Subject: AP1000 Response to Request for Additional Information (SRP3.4.2)

Response to Request for Additional Information on SRP Section 3.4.2

RAI Response Number: RAI-SRP3.4.2-SEB1-01
Revision: 0

Figure RAI-SRP3.7.2-SEB1-02- 1: Section E-E Radwaste Building

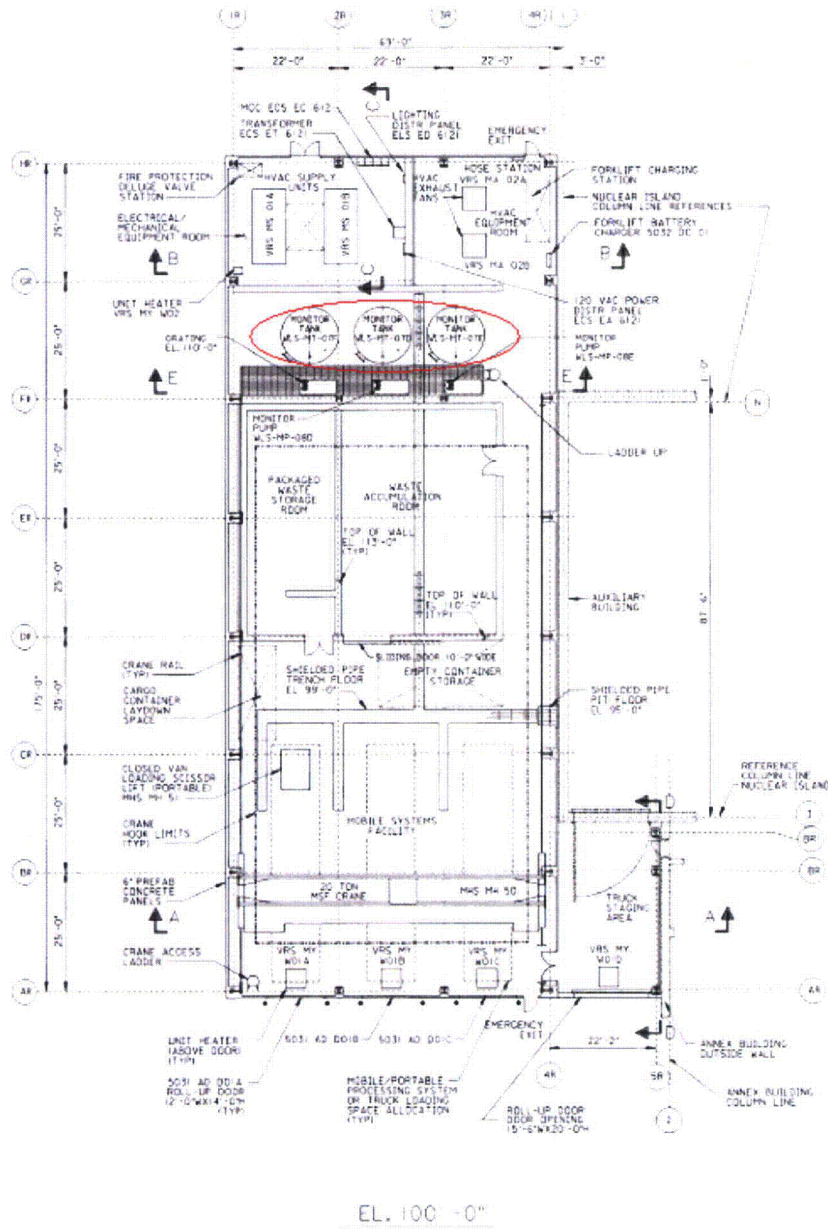
The design of the Radwaste Building has been amended to incorporate three new additional liquid waste monitor tanks and the associated piping systems (see TR-116).

Provide an analysis to show that external flooding caused by the release of the liquid from tank rupture and collapse of the Radwaste Building due to safe shutdown earthquake (SSE) or other extreme environmental events will not impair the structural integrity of the adjacent nuclear island (NI) structures.

The Radwaste Building is a nonseismic structure designed under the Uniform Building Code. Therefore, in the DCD the building is allowed to collapse. As a result of the design amendment where three heavy weighted tanks (with 15,000 gallon capacity each) are added to the building, a large amount of liquid may be released when the building collapse to cause tank failure due to SSE or other extreme environmental events. The released liquid could result in internal as well as external flooding. The internal flooding is of no safety concern as the SSCs inside the building are all non-safety related. However, the external flooding may produce large hydrodynamic loads exerted on the nearby NI Seismic Category I buildings, thereby threatening the structural integrity of the safety-related structures. Justification is therefore needed to demonstrate that safety will not be compromised when the external flooding takes place at the NI structures as a result of the potential collapse of the Radwaste Building and monitor tanks.

The three new liquid waste monitor tanks are located in the Radwaste Building between wall line FR and GR in Figure RAI-SRP3.7.2-SEB1-02- 1. As seen in this figure, the tanks are located in the area of the Radwaste Building that extends beyond the Auxiliary Building, which separate them from the Auxiliary building. It is unlikely the tanks will impact the south side of the Auxiliary Building directly. It is more likely that if the Radwaste Building failed and this failure caused a subsequent Monitor Tank(s) collapsed, the tanks would push the liquid contents to the west and outside of the Auxiliary Building and not a direct impact to the building.

In addition, if the contents of 3 tanks failed and all of the water flowed within the Radwaste Building the liquid would flood up to a level of 6 inches within the Radwaste Building outside dimensions. This would not create any significant hydrodynamic force on the Auxiliary Building wall.
